2.0 SITE CHARACTERISTICS

The principal purpose of this chapter of the SHINE Medical Technologies, LLC (SHINE, the applicant) operating license application safety evaluation report (SER) is to describe why the site selected is suitable for constructing and operating the SHINE facility.

Figure 2.4.5 - 1: Comparison of SSE (yellow) with uniform hazard spectra for SDC-3 and SDC-4 facilities using site-specific subsurface information.

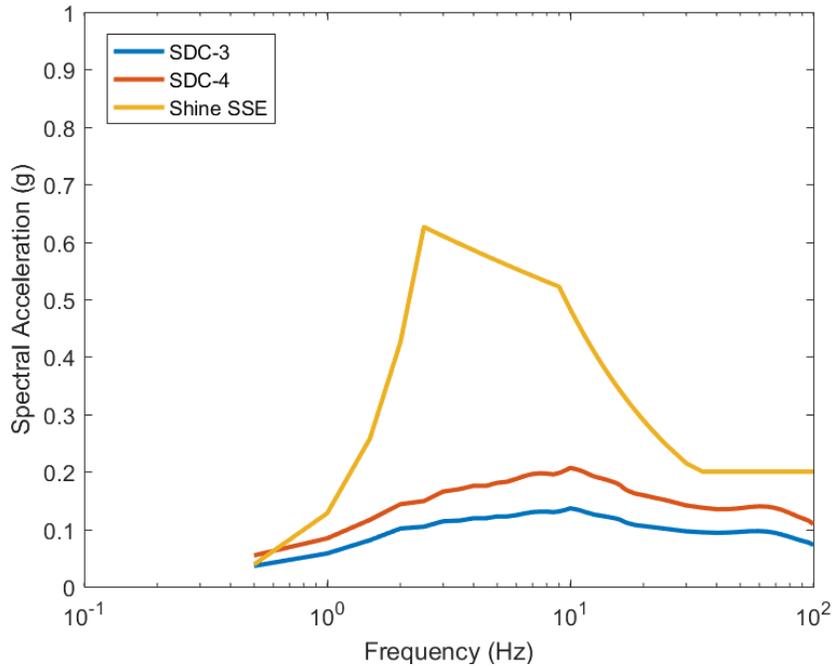
In addition to reviewing the application and USGS results, the NRC staff performed a confirmatory PSHA that incorporates at-site information about the subsurface geology to develop uniform hazard spectra at the surface for Seismic Design Classification 3 and 4 (SDC-3 and SDC-4) facilities as defined in ANSI/ANS 2.26-2014, “American National Standard Categorization of Nuclear Facility Structures, Systems, and Components for Seismic Design,” and computed following guidance in ASCE/SEI 43-05, “Seismic Design Criteria for Structures, Systems, and Components in Nuclear Facilities.” The staff used the seismic source model described in NUREG-2115, the ground motion model described in “EPRI (2004, 2006) Ground-Motion Model Review Project,” 2013, and the site-specific dynamic properties described by the applicant in a letter dated August 3, 2012 (ADAMS Accession No. ML13311A770). The staff’s results, presented in Figure 2.4.5-1, show that for an SDC-4 facility, the SSE envelopes the site-specific hazard at all frequencies greater than 0.6 Hz with significant margin. Greater margin is demonstrated for an SDC-3 facility.
